32215 Big Springs Road, Yoder CO 80864 Not to Scale

Markup Summary

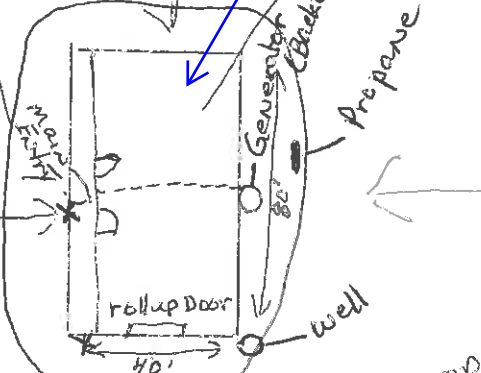
Parking lots in rural areas with fewer than 25 spaces can use rock, gravel, or other measures than pavement. The disabled space would have to meet the minimum standards for disabled spaces (ADA guidelines for universal parking design) and provide any required access aisles as required. Please show the proposed outline of the parking areas and label the proposed surface material. Even when unpaved, parking should meet the dimensional requirements of the Land Development Code Table 6-4.

Identify the building as either existing or proposed.

Label proposed location of truck loading area and/or turnaround.

Will outdoor storage be proposed? If so, please label location

Identify the surface type of the driveway and if it is existing or proposed.

If gate is proposed, provide a detail that shows material and height.

Show the distance between the gate and the edge of the road

Identify if the gate is proposed or existing

Add PCD
File No.
AL192
